Change Order No. 8

Project Name: City of Pflugerville Pflugerville Parkway – Greenlawn to Great Basin	HDR Project No.: 09669-88703
Project Owner: City of Pflugerville P.O. Box 589 Pflugerville, TX 78691-0589	Owner's Project No.:
Project Contractor: JC Evans Construction Co., LP 8660 183A Toll Road P.O. Box 1216 Leander, TX 78646	Date of Issuance: 8/23/10
	Date of Contract: October 28, 2008
Contract Period: 730 days

Change Proposal Request No. 9 (Not a Change Order)

**Change Proposal
Request No. 20
(Not a Change Order)**

**PFLUGERVILLE PARKWAY
 PICADILLY DRIVE
 LIGHTING PLAN**

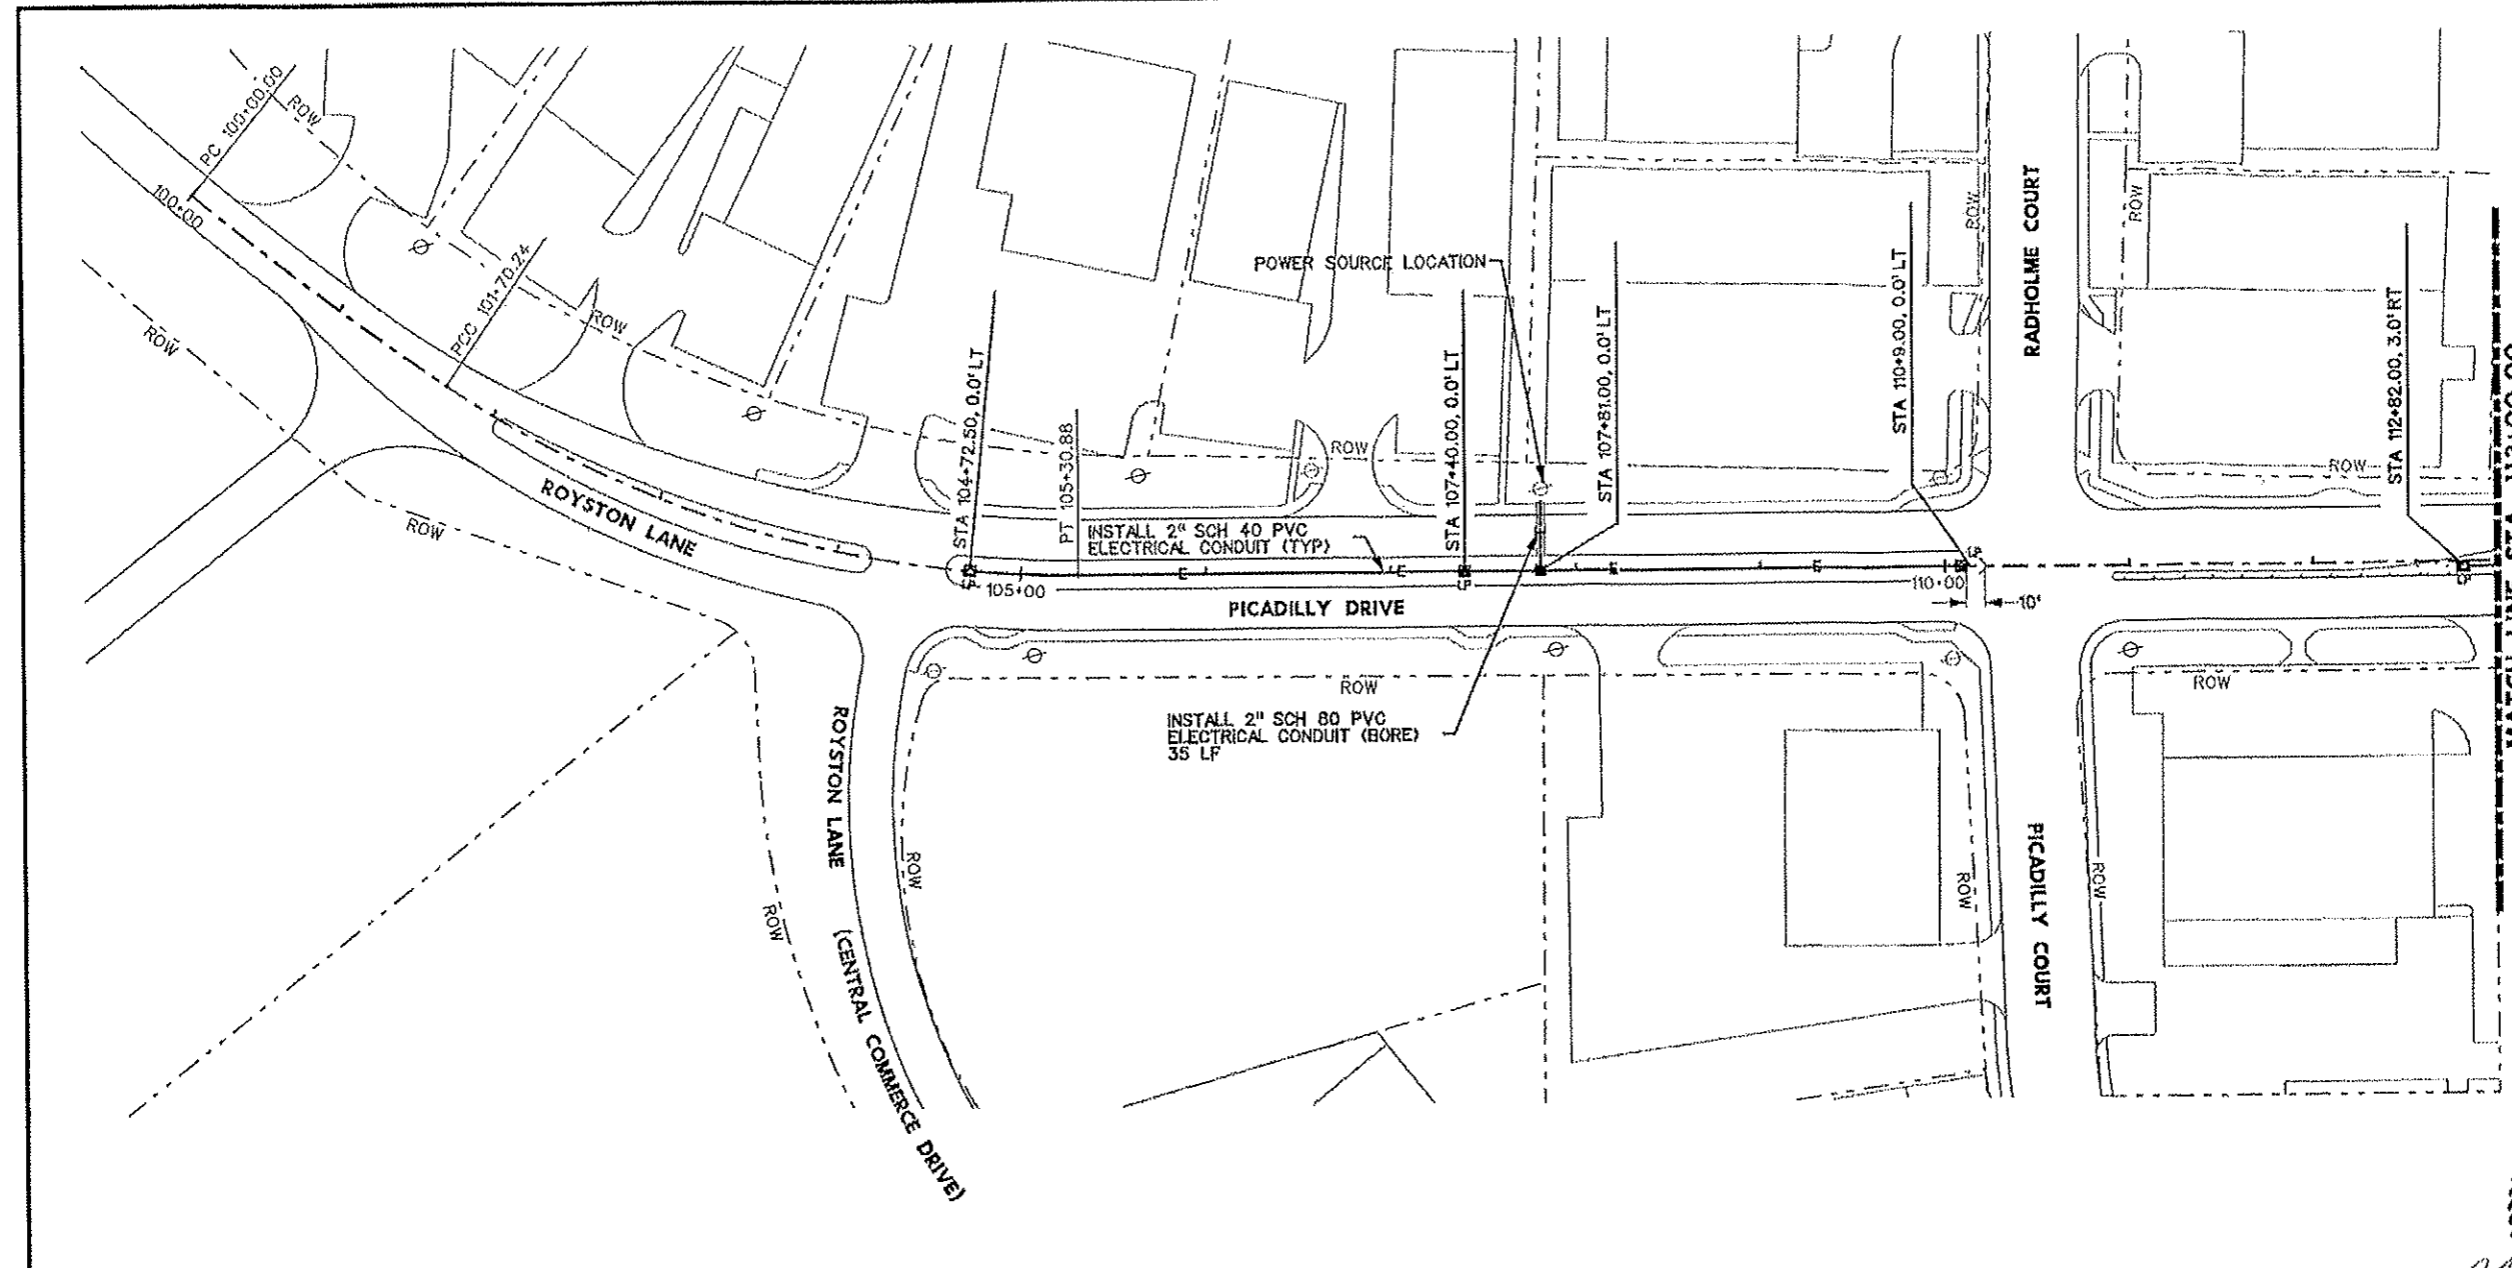
Per the City of Pflugerville's request, Additional quantities of lighting, conduit, foundations, and boxes to be constructed on Picadilly Drive from Royston Lane (Central Commerce Dr) to Cranston Drive as follows:

Item 416 **** DRILL SHAFT (RDWY ILL POLE) (24 IN)	Add 84 LF @ \$165.00/LF = \$13,860.00
Item 618 2018 CONDT (PVC)(SCHD 40)(2")	Add 2323 LF @ \$11.00/LF = 25,553.00
Item 618 2035 CONDT (PVC)(SCHD 80)(2")(BORE)	Add 419 LF @ \$19.80/LF = \$8,296.20
Item 624 **** GROUND BOX TY-A (ONCOR)	Add 19 EA @ 610.00/EA = \$11,590.00
TOTAL = \$59,299.20	
SHEET NO. 388,389,390 (Attached)
